Re: Application # 20 209863 ESC 20 OZ

**COMMUNITY CONCERNS
ABOUT LCH DEVELOPMENT
APPLICATION
(20 209863 ESC 20 OZ)**

3291 Kingston Rd., 2 and 4 Windy Ridge Drive

Cliffcrest Scarborough Village SW Residents Association
www.cliffcrestscarboroughvillagesw.ca / info@csvsw.ca

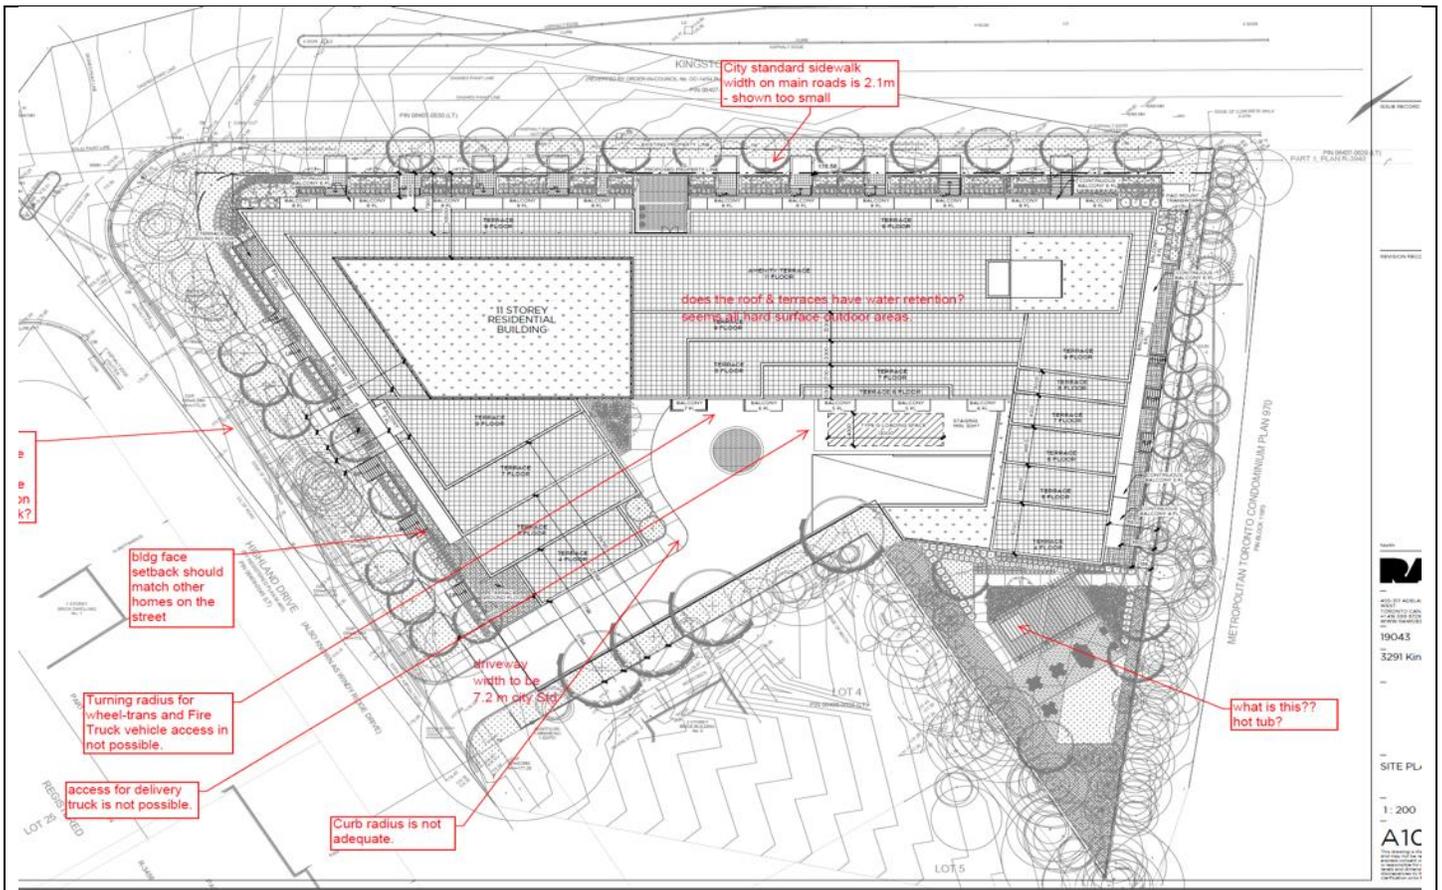
ARCHITECTURE PLANS		
Back to top		
Reference:	Original Text	Comments
Trees	Drawings	Trees depicted in the drawings that are new actually represent mature trees 30 + years down the line.

Today's mature trees (see Arborist Report) which present privacy screen for 6 Windy Ridge Drive are in danger of damage due to close proximity of the driveway and sound or visual barrier that will need to be erected should the development go forward.
Site coverage data	Drawings	The Architectural Plans have missing site coverage data for hard and soft surfaces. The building alone is 49% of the site area, not including entry decks, sidewalks, and asphalt paving. Looks more like 60% site coverage in total.
Parking	Drawings	The plan shows 25 on the ground parking spots, while the cover indicates 30.
Sidewalk on Kingston Road	Drawings	City sidewalk standard width on main roads is 2.1 meters and shown too small in the plan.
Sidewalk and setback on Windy Ridge Drive	Drawings	There is no room for the snowplows to pile the snow. Would this be on the sidewalk? If so, contrary to accessibility standards and the Accessibility for Ontarians with Disabilities Act. Building face setback should match other homes on the street.

Condo Driveway	Drawings	Driveway width is to be 7.2 meters city standard. Curb radius of sidewalk along driveway is not adequate. Access for delivery truck is not possible. Turning radius for wheel trans and fire truck vehicle access is not possible.
Water Storage Tanks	Drawings	Drawings do not show water storage tanks shown in storm water report.
Storm water Runoff	Drawings	The roof appears all a hard surface. Does the roof and terrace have water retention?
Outdoor amenity space	Drawings	Is there a hot tub on the back deck? In October 2002, the application was denied. The Scarborough Community Council, at its meeting held on September 14, 1999, after considering the deputations and based on the finding of fact, conclusions and recommendations contained in the report, dated June 4, 1999, from the Director of Community Planning, East District, concluded the Public Meeting under the Planning Act, and at its meeting held on November 9, 1999, deferred sine die the Director's recommendations until such time as the applicant should request that the matter be reconsidered. The Scarborough Community Council recommended that the applications by George and Cindy Samonas be refused for the following reasons: (a) <i>the proposed uses, and the day nursery space in particular, are inappropriate in such close proximity to the abutting residences;</i> (b) the in-right, out-right access to Kingston Road is potentially unsafe; and (c) the lot size and configuration are inadequate to provide the necessary parking requirements in accordance with City parking standards. https://www.toronto.ca/legdocs/2002/agendas/council/cc021029/sc9rpt/cl012.pdf

Loading space	Drawings	The loading space is disconnected from the elevator and moving room.
Waste room	Drawings	Indoor waste room with single door will not work with bins.

Table 5: Dwelling type composition in Study Area and City of Toronto

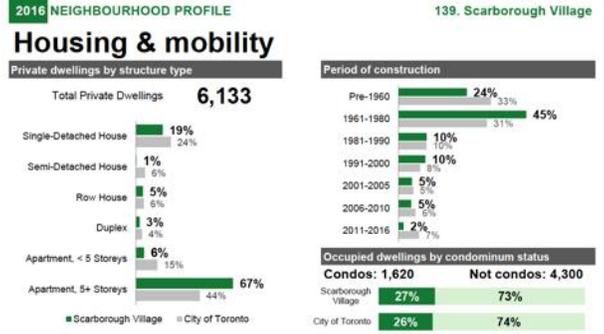
p. 9	Table 5, a comparison of dwelling types in the study area compared to the City of Toronto	As an example of the inaccuracy of this demographic study: apartment buildings that are 5 or more storeys within Scarborough Village account for 61% of the dwelling types, compared to the City of Toronto (see figure 1 below), not 45%.

wrong
see
following
attached
below

The above chart is from the 2016 Neighbourhood Profile for Scarborough Village compared to the 2011 data that was presented in LCH's Avenue Segment Report.

NOTE: H denotes height above grade. Applicant submitted drawing.

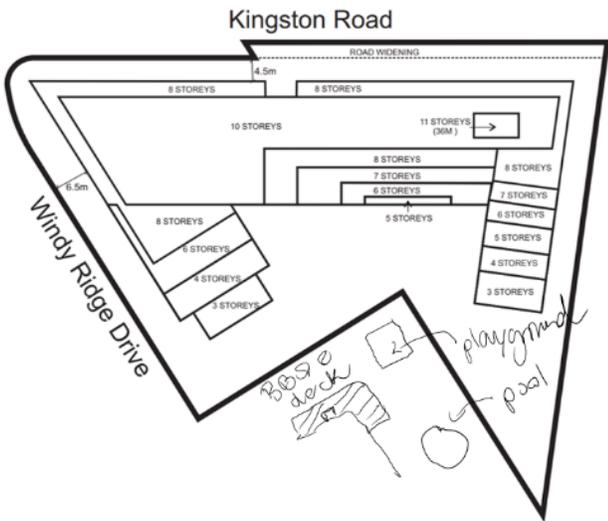
Reference	Original Text	Comments
	"Whereas Council has provided adequate information to the public and has held at least one public meeting in accordance with the Planning Act..."	Information provided was inaccurate as per the comments provided in this document.
Site Specific Provisions	"(F) No building or structure may penetrate a 45-degree angular plane projected from 0.1 metres above the average elevation of the ground along the rear lot line. The following elements of a building or structure may penetrate the angular plane as follows: a. Parapet walls, privacy screens, planters, stairs, wind mitigation elements, trellises, guards, guardrails, outdoor amenity space elements, landscape features and green roof elements."	a. should be deleted.
	"(G) A building or structure must be setback a minimum of 4.5 metres from Kingston Road and 6.5 metres from Windy Ridge Drive;"	<p>(G) A building or structure must be setback a minimum of 4.5 metres from Kingston Road and 6.5 10.7 metres from Windy Ridge Drive;</p> <p>This should read 10.7 meters to comply with current Zoning By-law setback requirement as residences on Windy Ridge Drive.</p>

"(J) Parking spaces must be provided at a minimum rate of 0.75 spaces for each dwelling unit;"	<p>Should be 1 per unit since this is a car-oriented community.</p> <p>This development is located 5 to 8 km from Warden subway station (depending on route taken) and a little over 1 km from the GO Station, which is beyond usual walking distance. Most amenities are driving distance and require a car. Therefore 1 space per dwelling unit plus visitors parking must be provided. A typical suburban ratio is 1.2</p>

FISHER	NORTH	LEGEND	PROJECT NAME AND ADDRESS	PROJECT NO. FE-P-19-0651	FIGURE 1	SHEET NO.
---------------	-------	--------	--------------------------	-----------------------------	----------	-----------

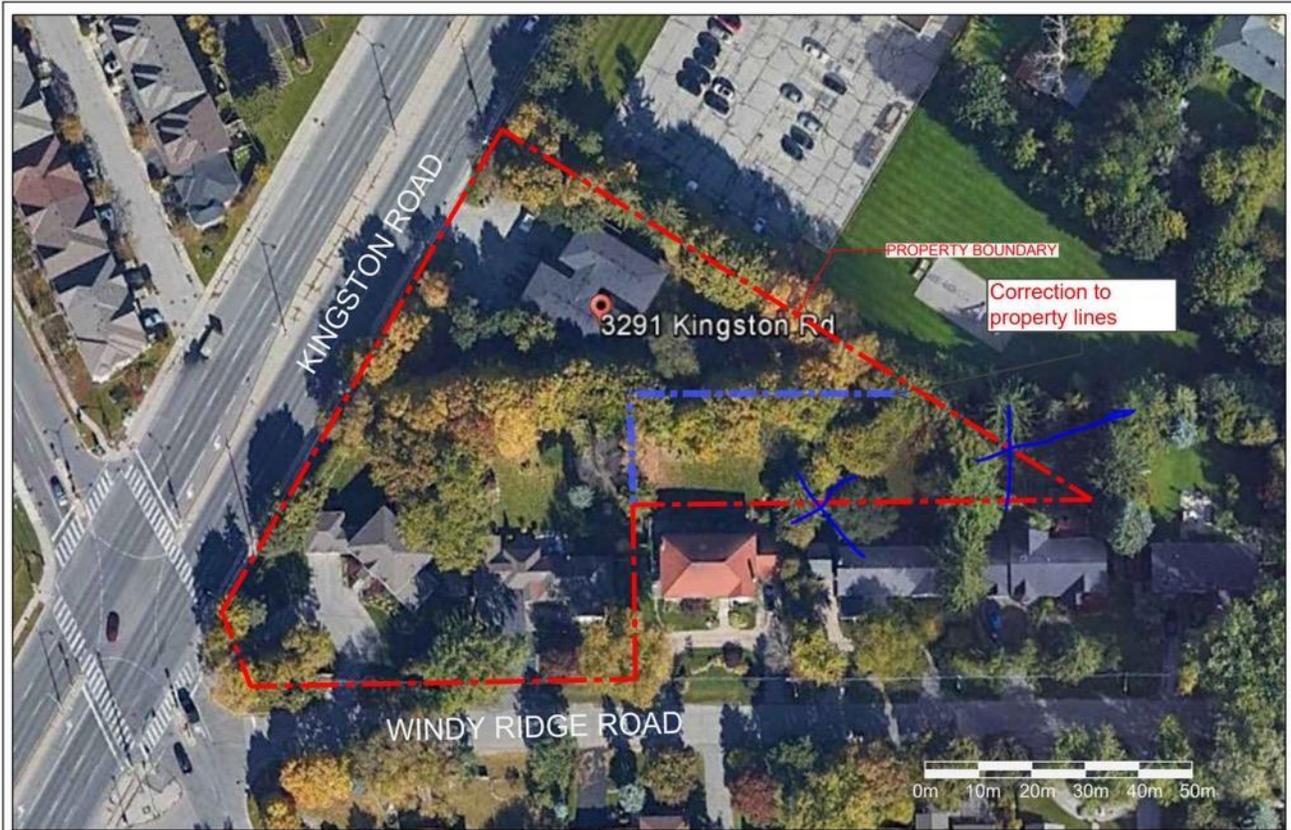
Reference	Original Text	Comments
	The study has only one interviewee, George Samonas.	Given that he is putting forward the application, does this not present a conflict of interest and question the reliability of information? The study demonstrates clearly the potential of soil contamination - what are the next steps?
P. 37	Boundary lines of development site.	Wrong boundary line of adjacent properties, see Figure 1 below.
